MEETING:	PLAN COMMISSION
DATE AND TIME:	<u>MONDAY, JULY 11, 2016 6:30 p.m.</u>
LOCATION:	Germantown Village Hall Board Room

- C. ESI Design Services, Inc. for Freistadt All-Temp LLC – N120 W18737 Freistadt Road. Site Plan Review for a 40,549 sqft Warehouse Addition.
 - D. Presbyterian Homes of Wisconsin, Inc. for Germantown Commerce Center, LLC & Romano & Schmidt, LLC – N112 W17300 Mequon Road. 2-Lot Certified Survey Map Application, Planned Development District (PDD) Amendment and Site Plan Application for a 190-unit Senior Housing Community.

Re: Plan Commission Submittal for Presbyterian Homes of Wisconsin

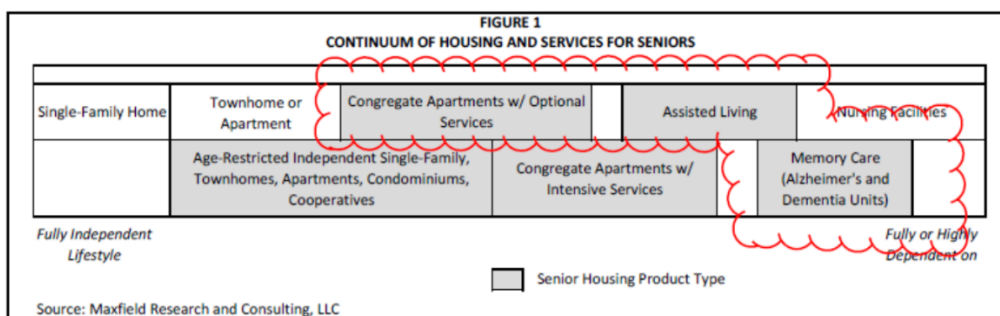
17. The architectural plan set presents little if any detail on the type, color of materials proposed for the buildings, window systems, etc. A statement of design intent (i.e. explanation of design, architecture and materials) is required; along with a material sample board.

Response: The design intent is to provide a building with a Germanic or Bavarian feel, but not literal translation. The exterior base and many bays will be clad in a cultured stone product that is square cut in keeping with a castle stone look. The remainder of the building will be a durable siding product, such as LP or Hardie, in two colors. We have added gable end trim, clipped gable ends, brackets below overhangs and trellised decks at various locations for the suggestion of Germanic tradition, while not being overly literal. A sample board will be provided for the Plan Commission Meeting.

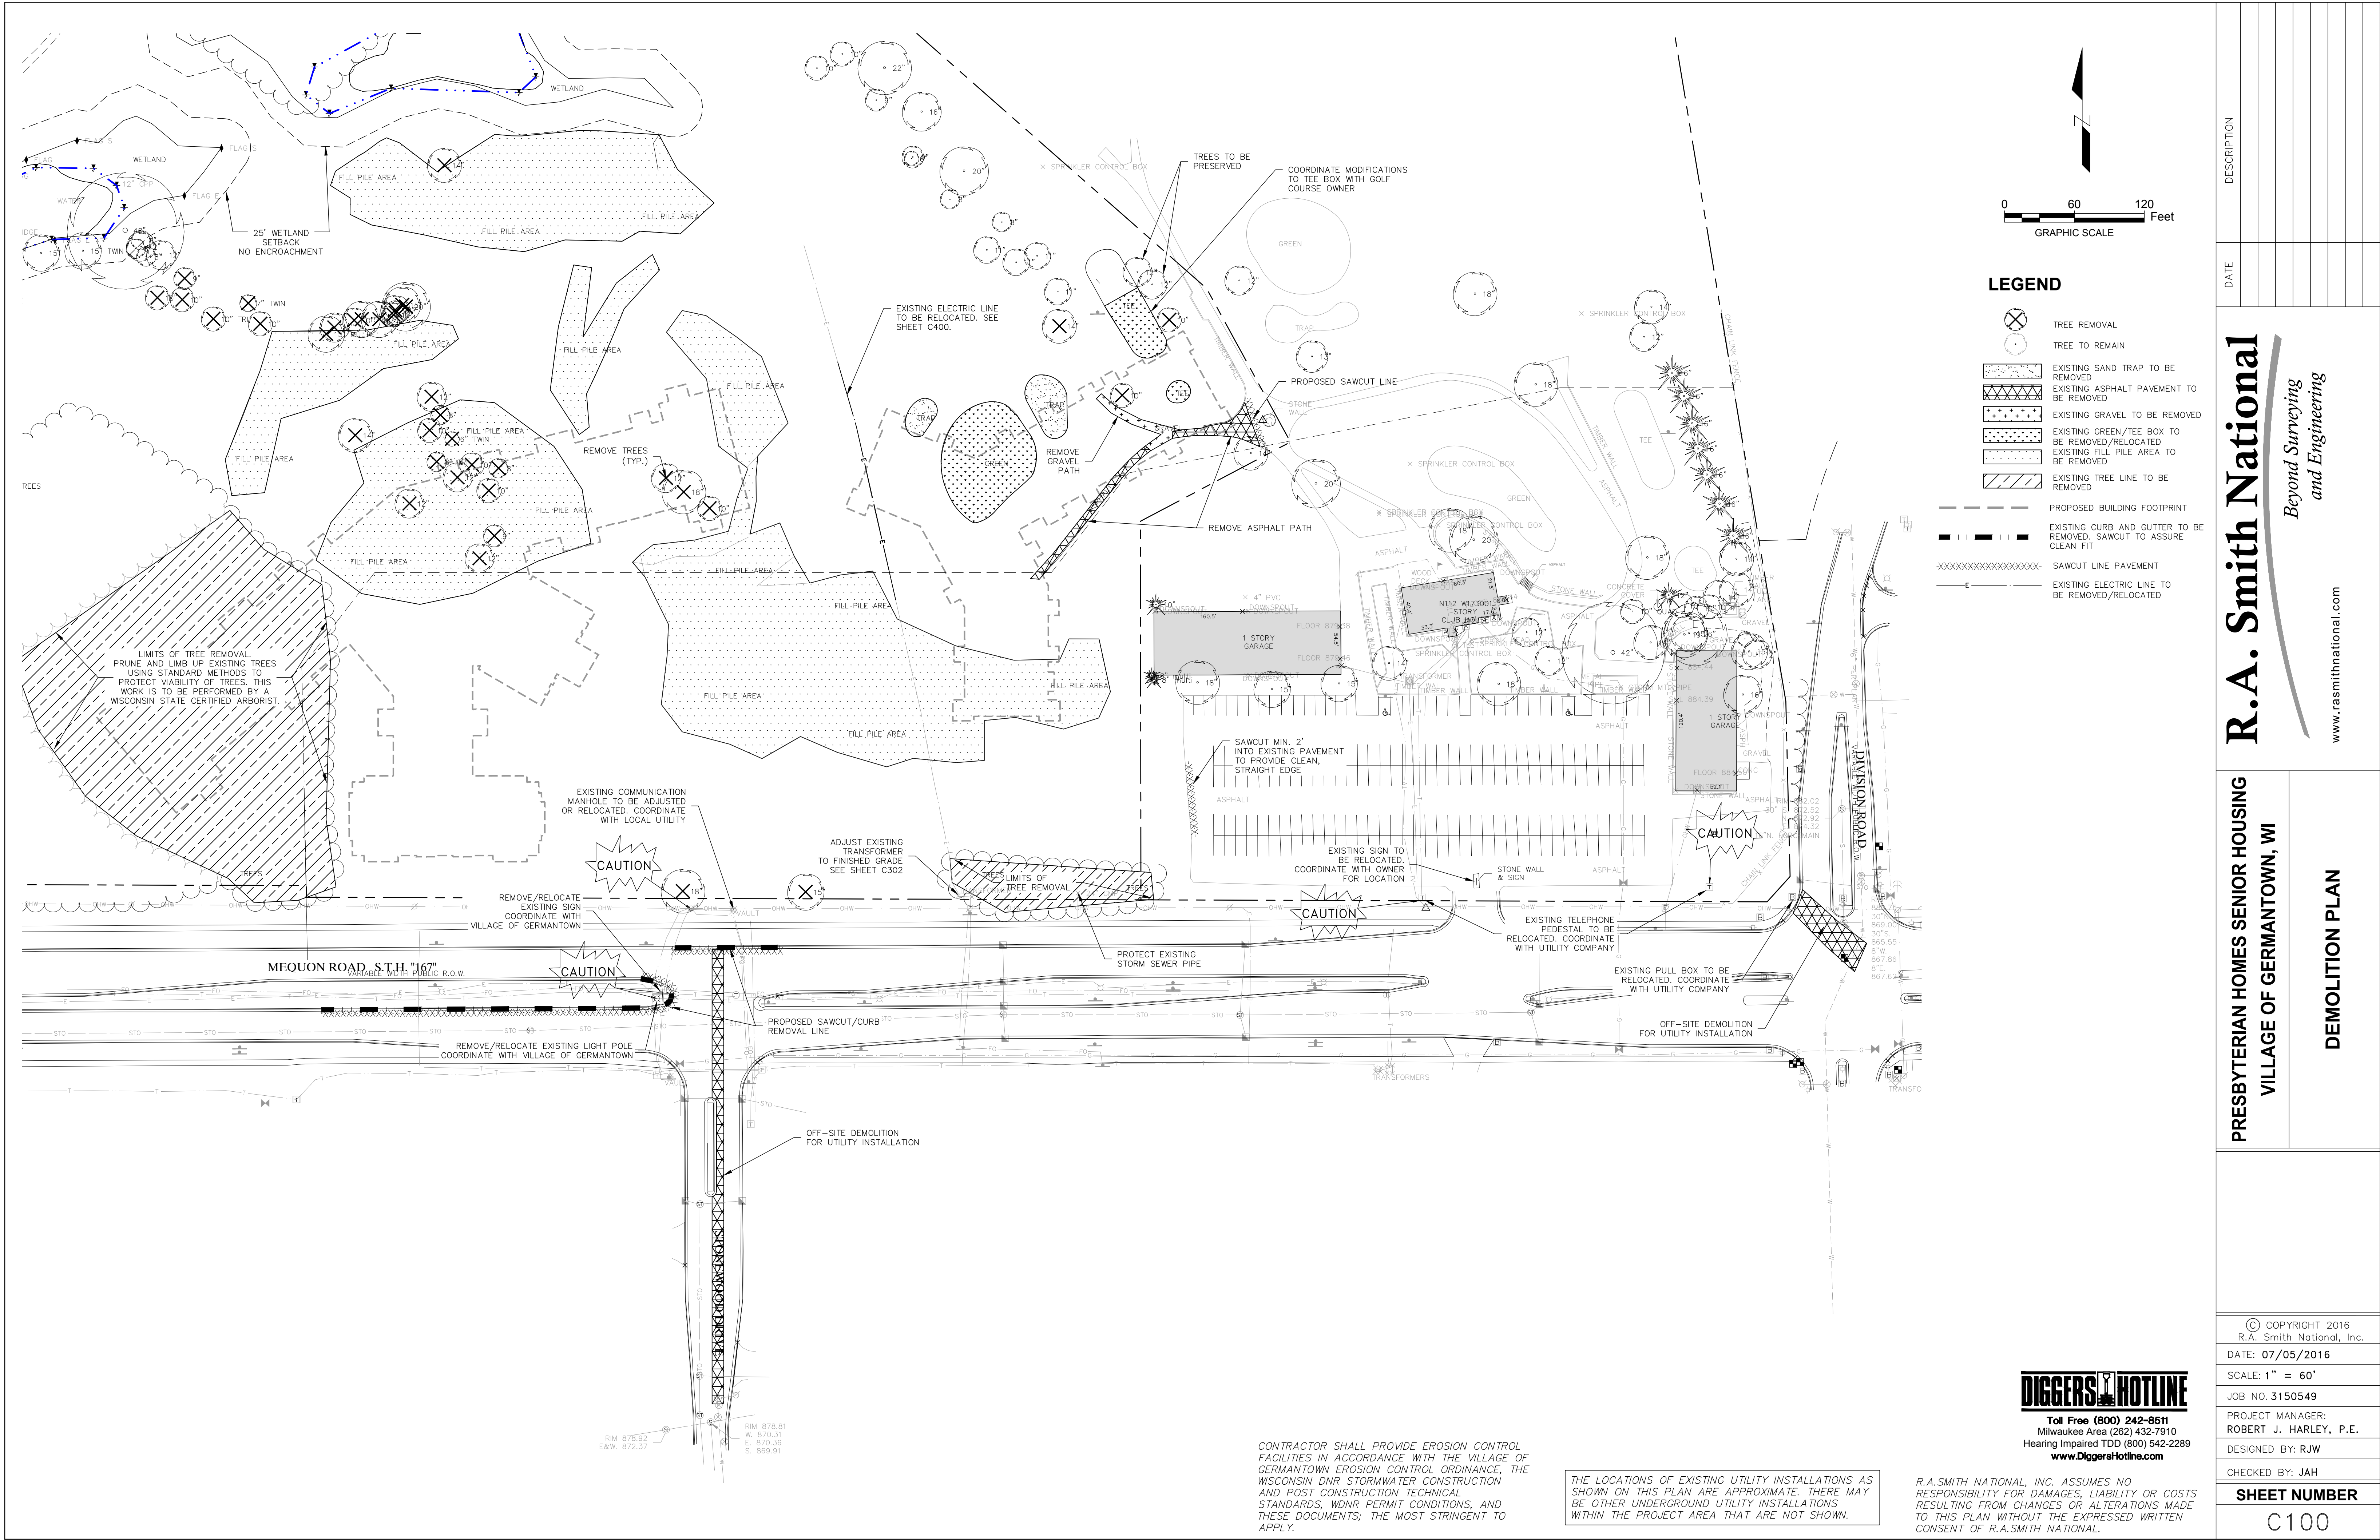
9. Site Statistics Table (Sheet C200). Please present a calculation (sqft area and %) of the amount of green space (presumably outside of the 13.15-ac “improvement area”) that will be subject of the easement agreement with the golf course. You need to try and avoid or minimize the “no joint use” restriction (i.e. using required non-impervious/green space to satisfy one requirement while simultaneously using the same green space for the golf course use). It appears that the minimum requirement for 65% of the parcel kept in “open space” on the BCSH parcel can be met exclusive of the area also being used for the golf course easement, but we need to see the calculation.

11. Site Statistics Table (Sheet C200). Depending on what area of the site is being referred to, the zoning district and land use is incorrectly listed as Rm-2/PDD.

12. Site Statistics Table (Sheet C200). The EH District regulations require a minimum street/front yard setback equal to 3 times the height of the building (not 30 feet as shown in this table and on the plans), and, a side yard setback of 25 feet. While there are PDD amendments proposed to change the height and setback requirements, the correct information presented here needs to jibe with what the actual regulations are eventually amended to be.

13. Site Statistics Table (Sheet C200). The table should be revised to include the same information presented in the "Proposed Lot Area Exhibit" attached to the May 11 submittal letter?

Exhibit depicts a 17.03 acre upland area. The Site Statistics Table on Sheet C200 provides a green space calculation based on this upland area. The calculation indicates that 517,902 square feet (69.8%) of the upland area is green space which exceeds the minimum requirement of 65%.

Response: The Site Statistics Table on Sheet C200 has been revised to reflect the correct zoning/land use.

Response: The Site Statistics Table on Sheet C200 has been revised to reflect the actual setbacks based on the amended PDD. This table is also provided on Page 2 of 2 of the GDP.

Response: The Site Statistics Table on Sheet C200 has been revised to reflect the same information presented on the Proposed Lot Area Exhibit. This table is also provided on Page 2 of 2 of the GDP.
